BOBCAT OF NEW HAMPSHIRE

SITE PLAN APPLICATION # 11-21

STAFF REPORT #2

October 27, 2021

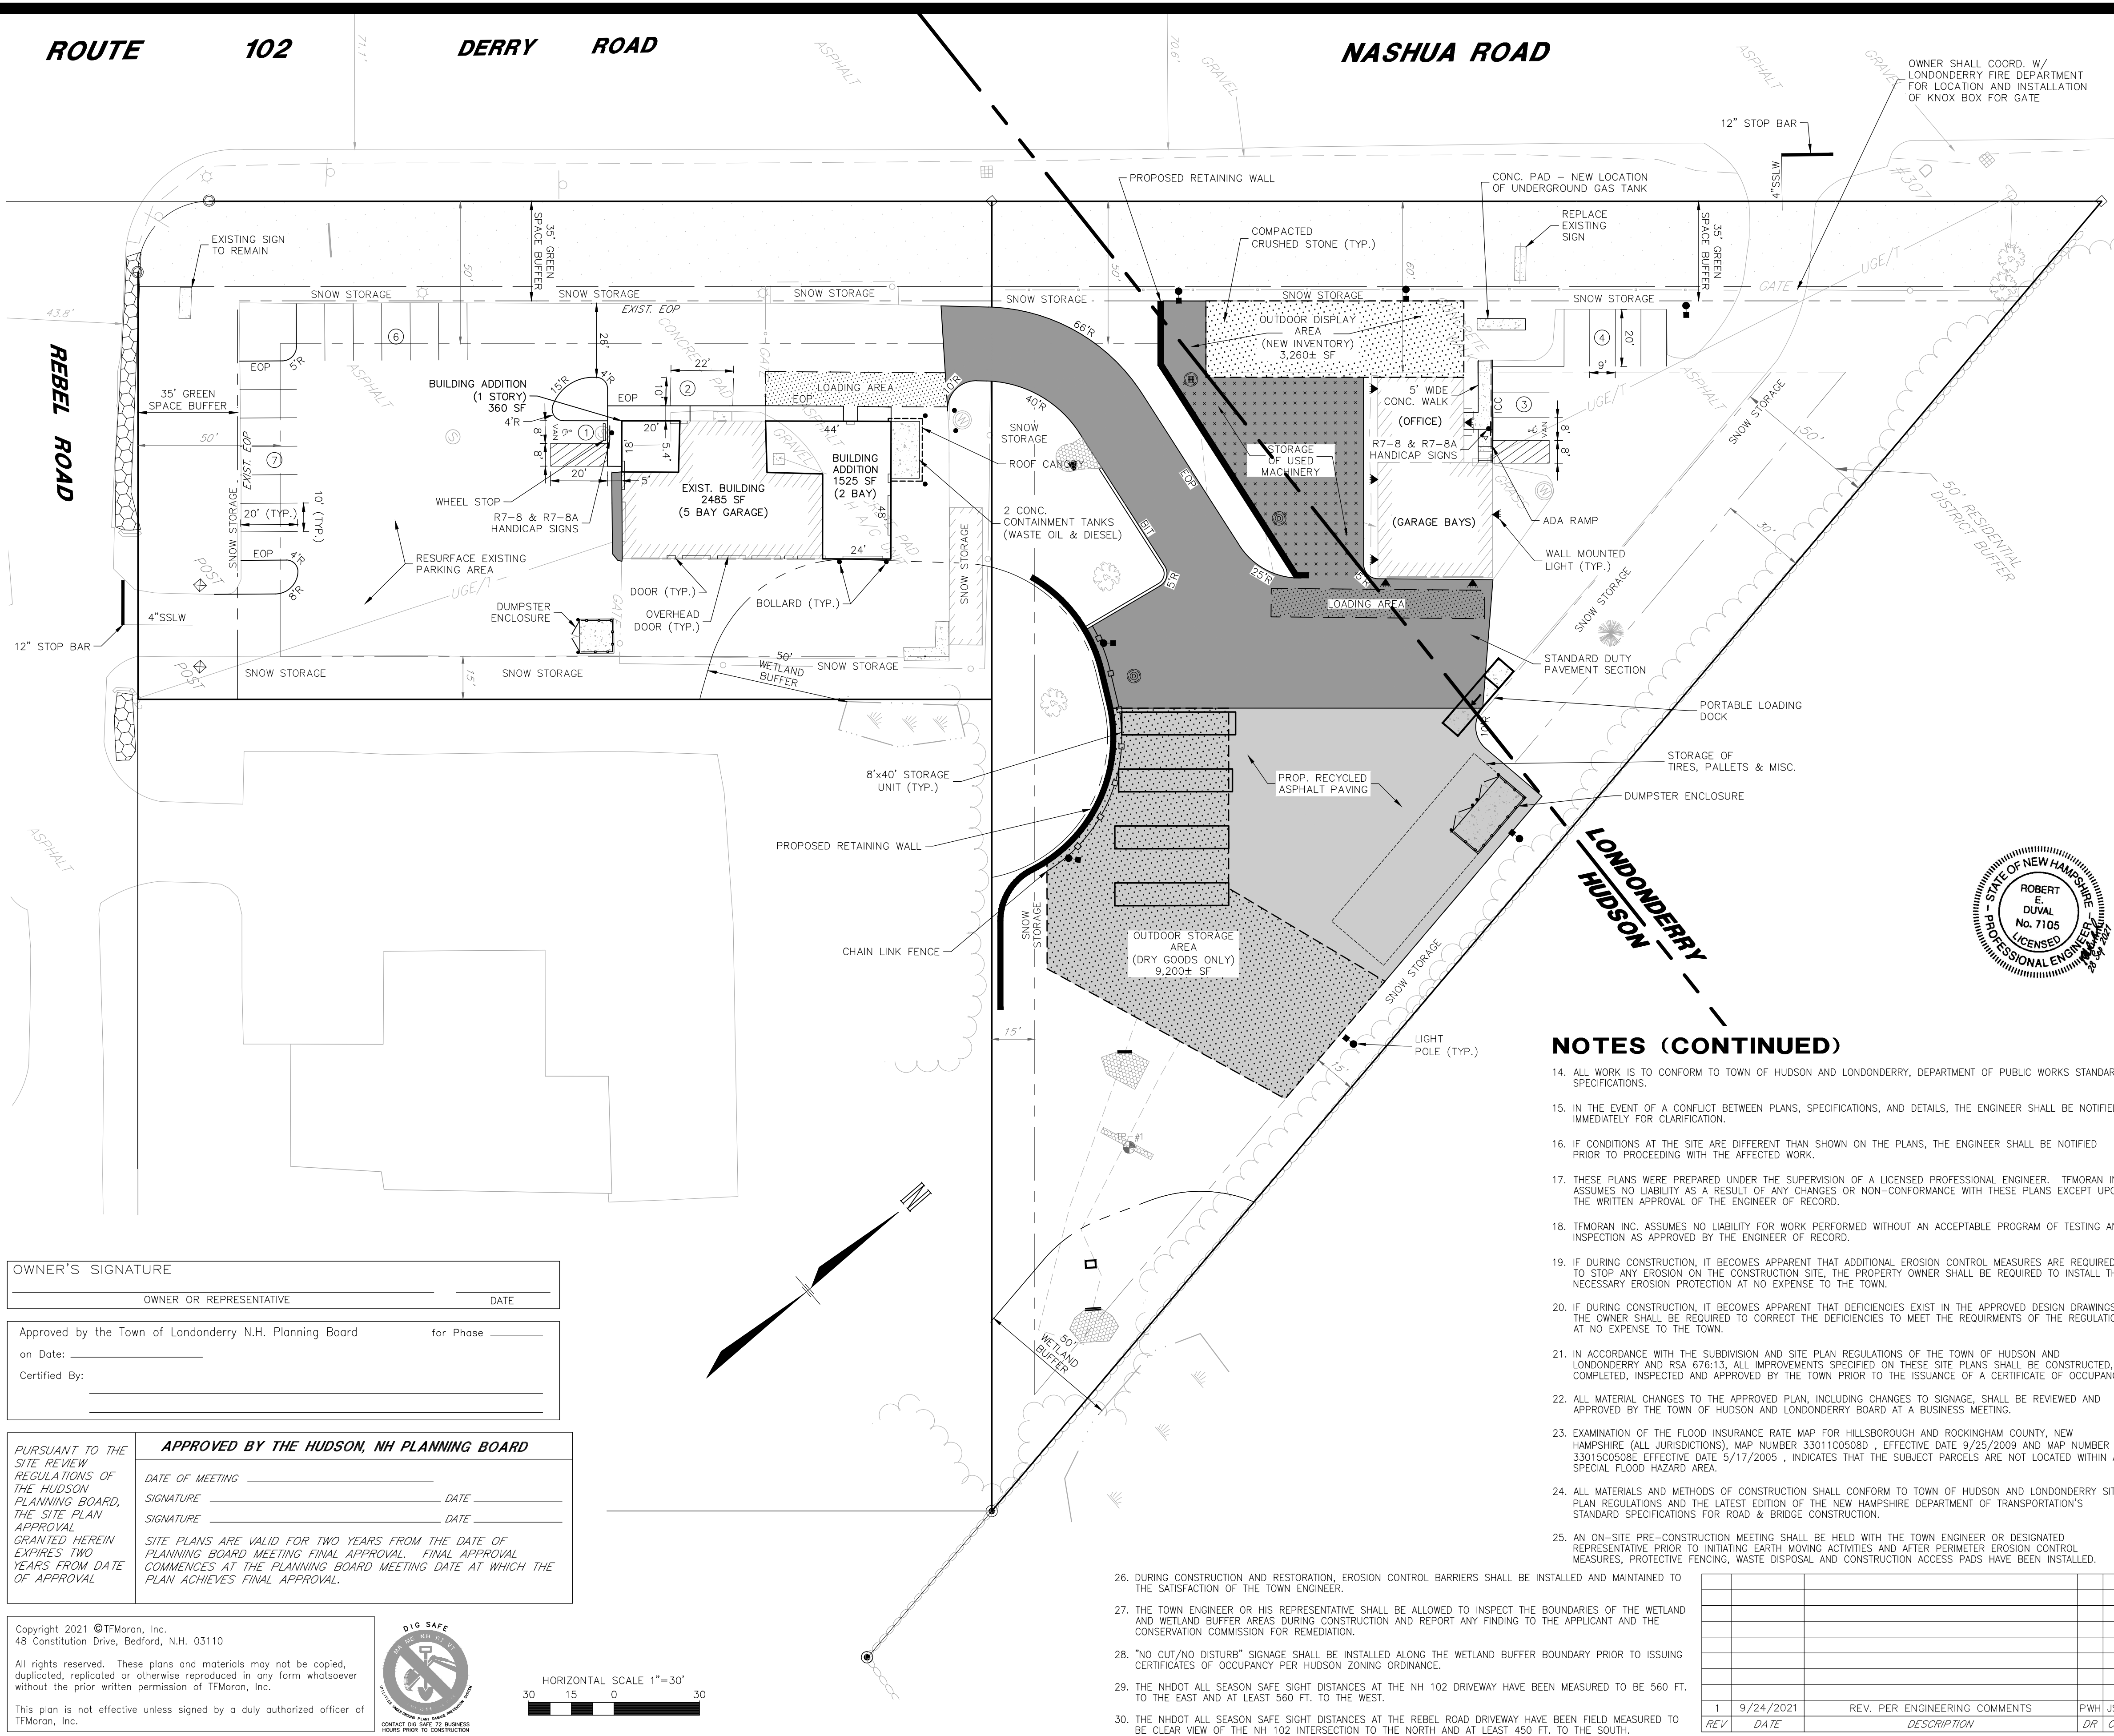
1. **Wood Shed on Lot 18:** The Site Preparation Plan on Sheet 4 (C-3) noted the wood shed on Lot 19 will be removed and other sheets in the plan set designate the footprint of the removed wood shed as snow storage. However, the plan set is unclear whether this area will be paved or landscaped.

Moreover, staff notes that part of the footprint is within the wetland buffer / Wetland Conservation Overlay District, and suggests the Applicant shift the snow storage area out of and away from the buffer/District.

FILE NO. 17851-08	DR	PWH	FB	
	CK	JSH	CADFILE	17851-08 SITE PLANS
				C-4

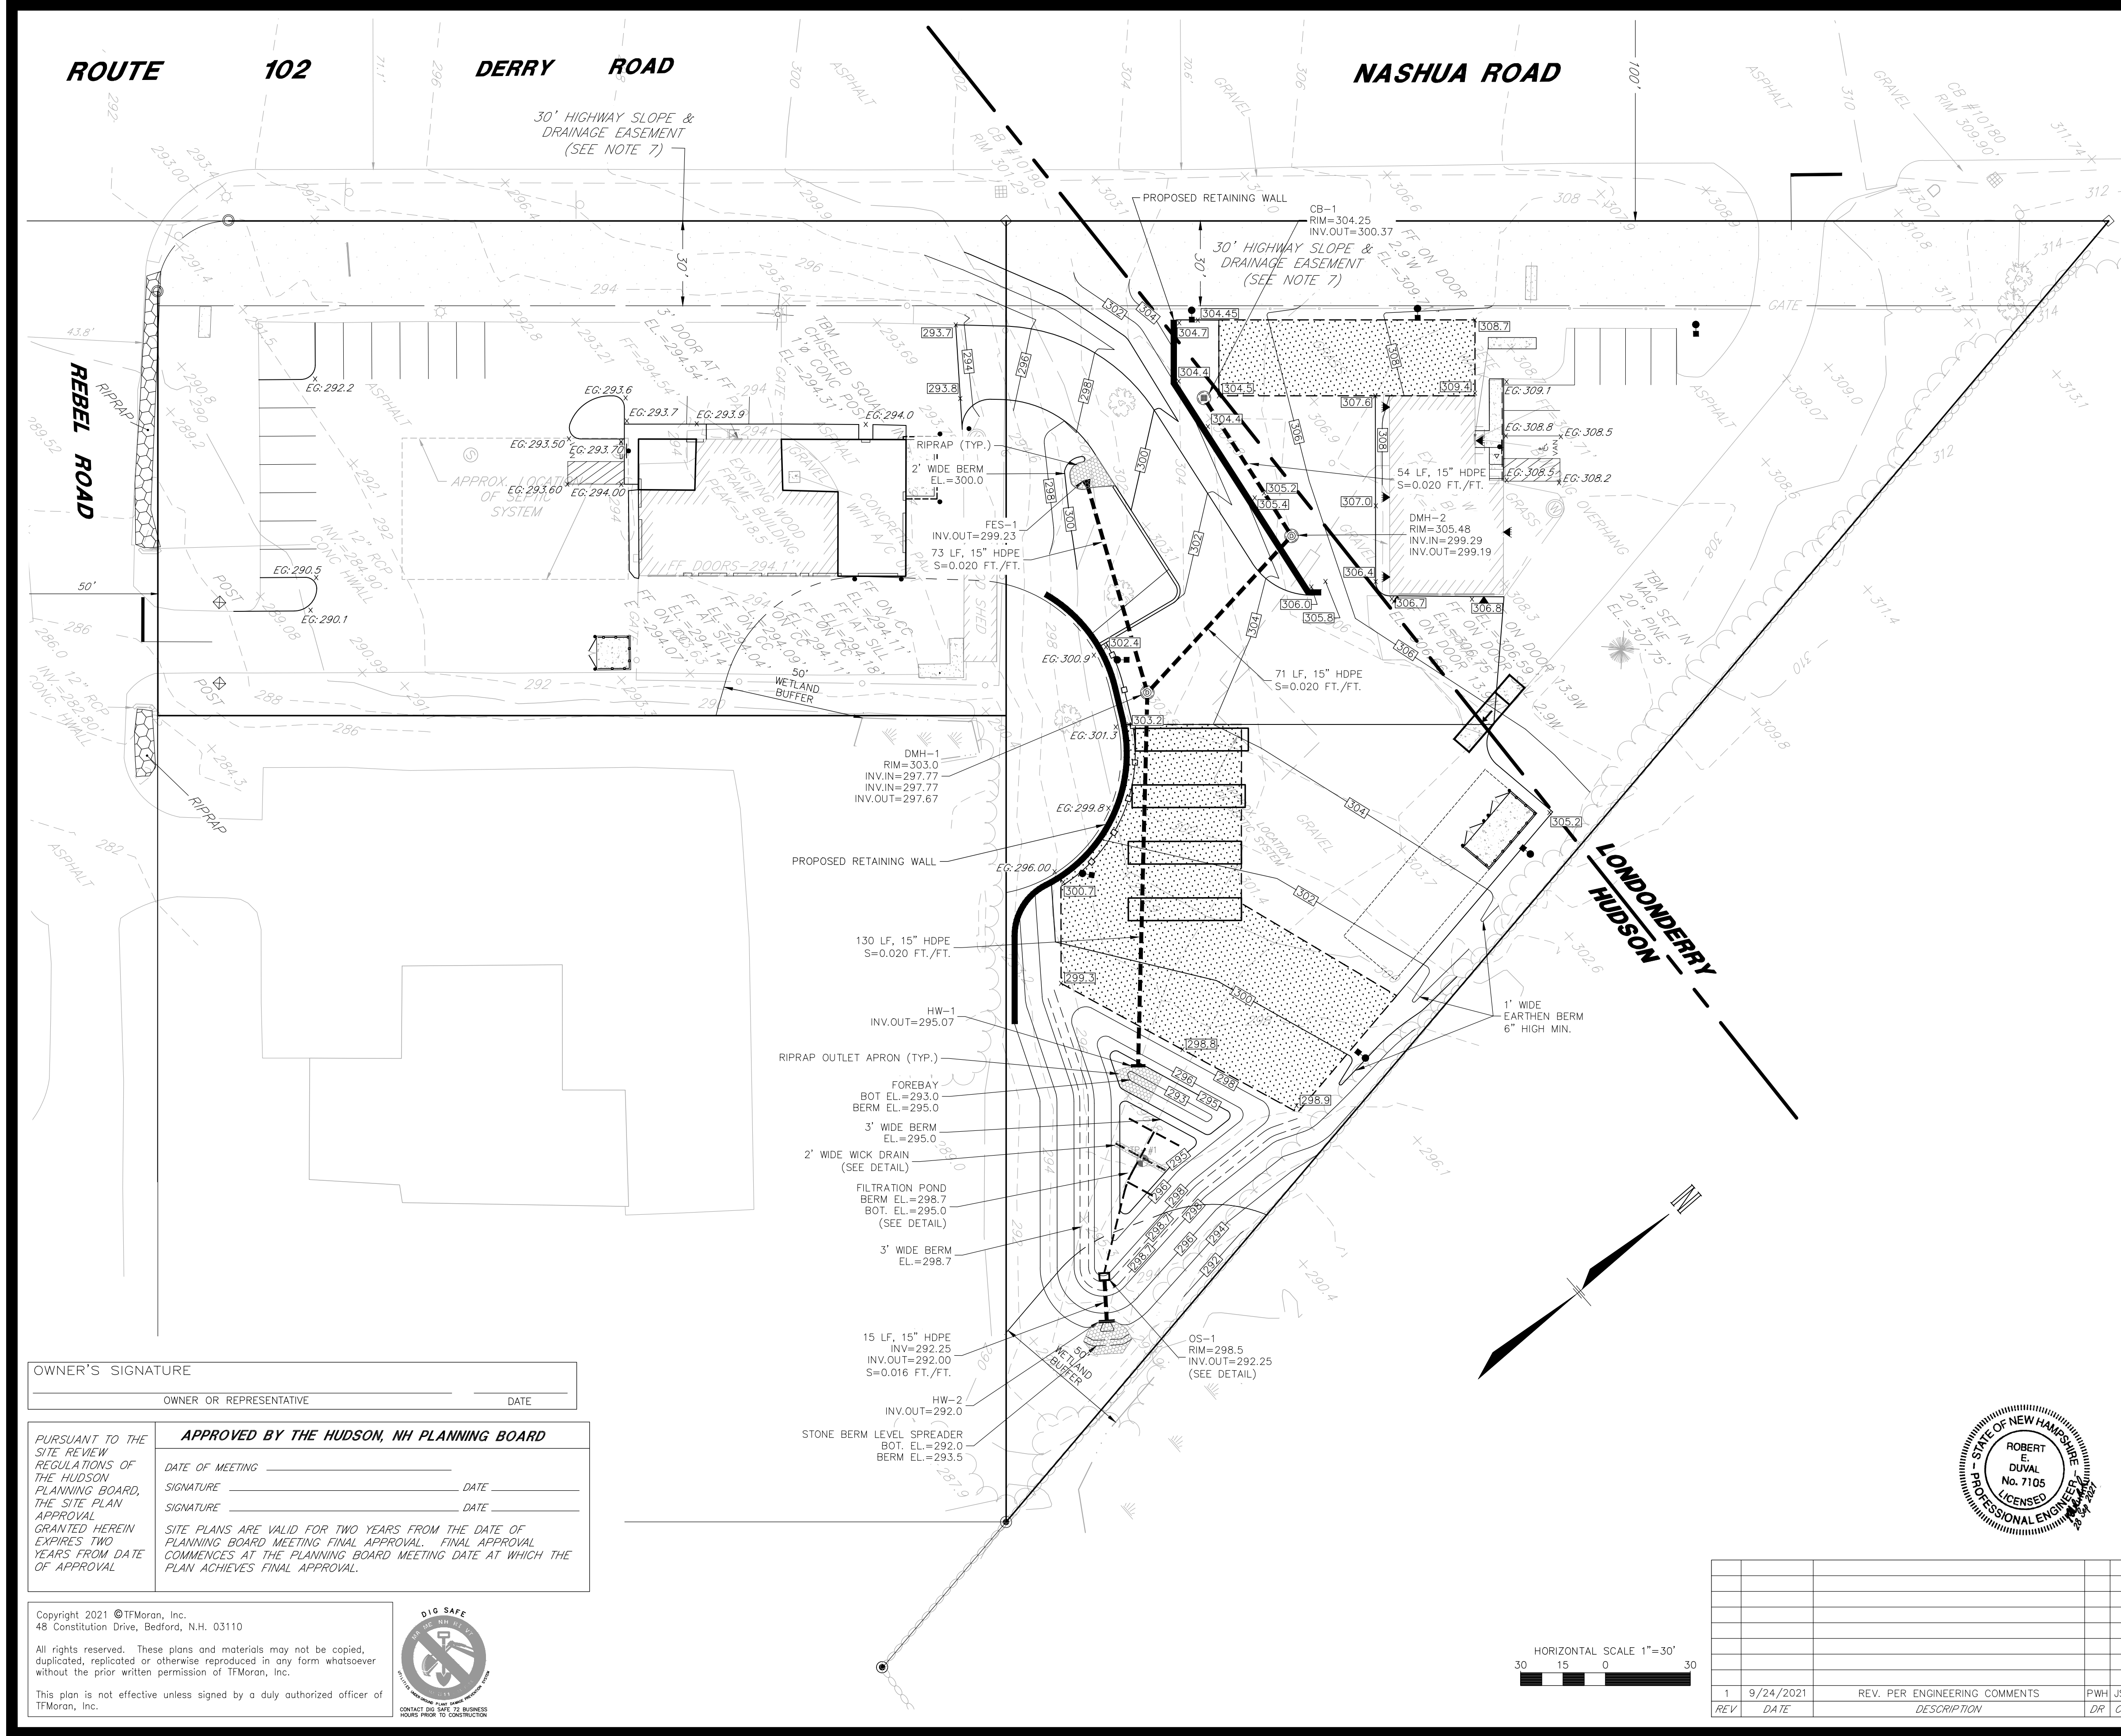
2. **Rear Lot Line & Setback for Lot 19:** Note #2 on Sheet 5 (C-4) states rear setback is not applicable to Lot 19. Even though the side setback is identical to the rear setback in case of the Business District (both being 15'), staff notes that the Applicant has the option of choosing the rear lot line pursuant to the Zoning Ordinance § 334-5 "Lot Line, Rear" and the rear setback is applicable to Lot 19.

3. **No Cut/No Disturb Signage Details:** The Applicant added Note #29 on Sheet 5 (C-4) in response to Conservation Commission's comments. Staff suggests the Applicant include placards demarcating the wetland buffer.

RECYCLED ASPHALT PAVEMENT SECTION

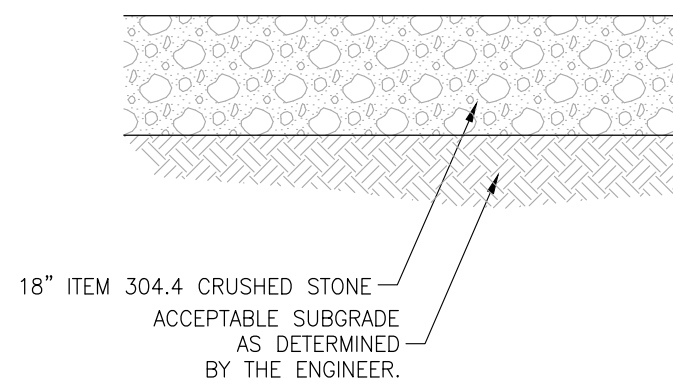
4. The conservation commission recommends that the Planning Board require the applicant to use a standard asphalt paving material in the area where recycled asphalt is proposed to help reduce infiltration of contaminates through the more pores recycled asphalt material.

We have updated the plans to stipulate the areas where machinery shall be stored and the area where dry goods can be stored. The areas where machinery will be stored have been converted to standard asphalt paving with catch basins having oil- gas hoods for control of petroleum contaminants prior to discharge into the drainage pond. The areas where the dry goods storage are proposed will not have a potential for fuel/oil leaks. For these reasons, the proposed hardpack gravel / recycled asphalt is an appropriate finish condition.
